HERITAGE PRESERVATION COMMISSION REPORT
Certificate of Appropriateness- Downtown Commercial Historic District.
Section 115-320(d)(2)

TO: Heritage Preservation Commission
FROM: Planning Staff
MEETING DATE: July 20, 2017

PROPOSAL: The applicant is proposing to perform the following work on the east facing (rear) facade:

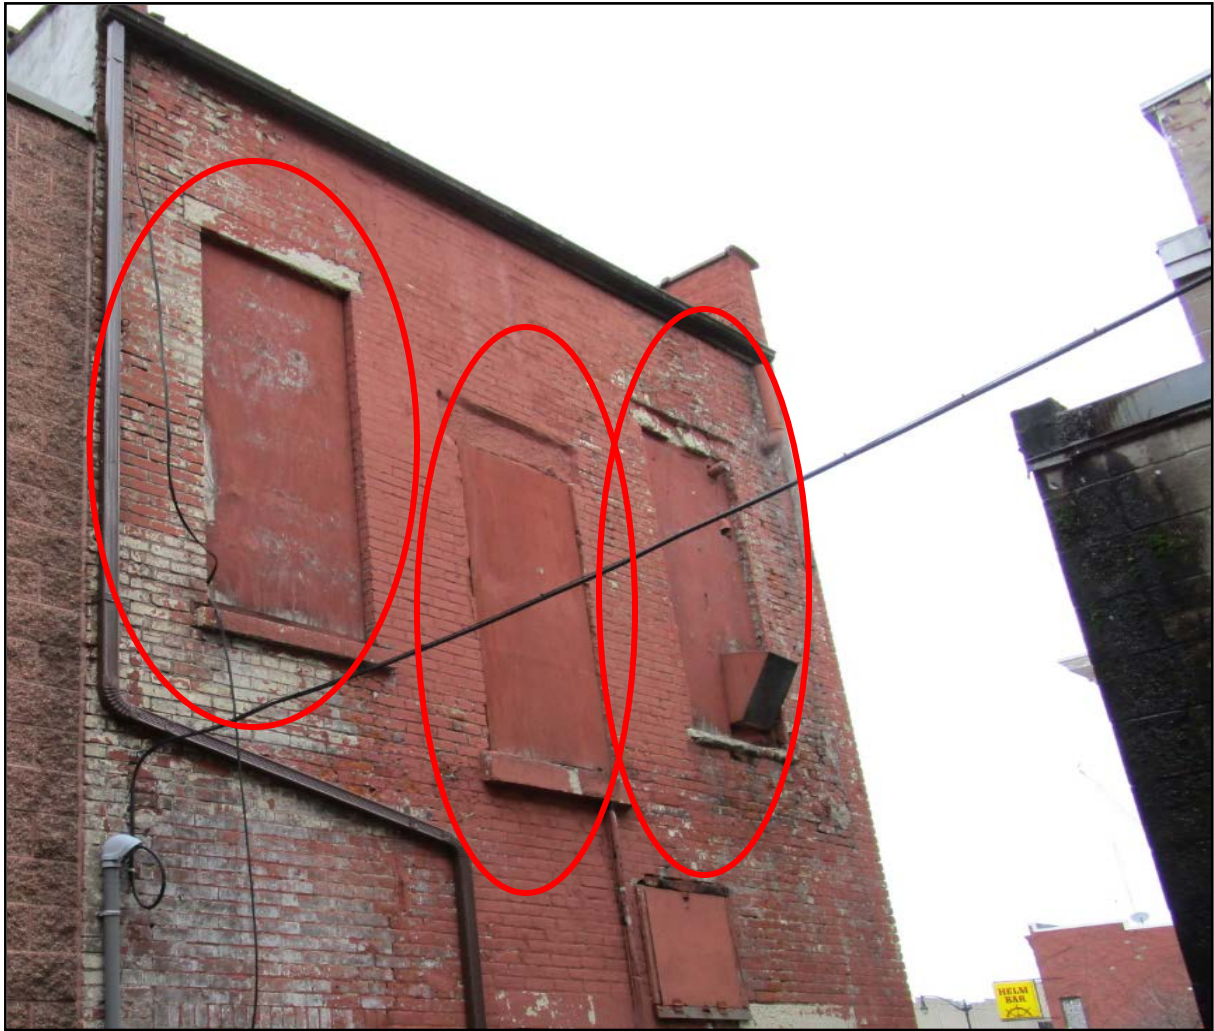
PROJECT DESCRIPTION: The applicant was issued an Order to Correct from the Fire Prevention and Building Safety Department in December 2016 that included the repair of the masonry and brick on the rear façade and the removal of non-permitted siding materials within five (5) openings. SEE BELOW PICTURES

The applicant is proposing to install windows (2) in the upper floor windows openings and install a door in the middle upper floor opening. The applicant has stated that this opening was originally a doorway. The applicant is also proposing to replace the opening above the first floor door with a window and fill in the two (2) openings on the first floor with brick. The applicant has stated that they would prefer to brick them in rather than replace with windows and they feel that windows on this façade would be continually damaged and need to be replaced. Additionally there is some mechanical located on the interior side of one of the openings.

Replacing the window openings with anything other than a window is not consistent with the Downtown Design Standards or the Secretary of Interior's Standards for Rehabilitation.

If the door way on the second floor is original to the building then replacing it would be consistent with the design standards though staff is not sure what function the door would serve. The door is fiberglass with an oak finish/appearance, which, while not wood as preferred would give the appearance of wood with more durability.

Installing windows in the second story openings, tuck-pointing, and installing a window over the first floor door are in keeping with the historic character of the building. Filling in the window openings on the first floor is not in keeping with the historic character of a historic building, however, existing interior conditions may make it difficult to install one. Brick is the preferred option instead of a window. As this is located on the rear/alley façade of the building the visual impact is minimal, especially since other window openings on this façade will be converted to windows. Staff is undecided about the door. If a door was historically located here, which seems evident by how much lower on the façade this opening is compared to the other two, then installing one is consistent with the design standards. The style of the door seems out of character of the building but since it is located on the rear façade there will likely be little visual impact.

This Certificate of Appropriateness is recommended for approval s submitted.
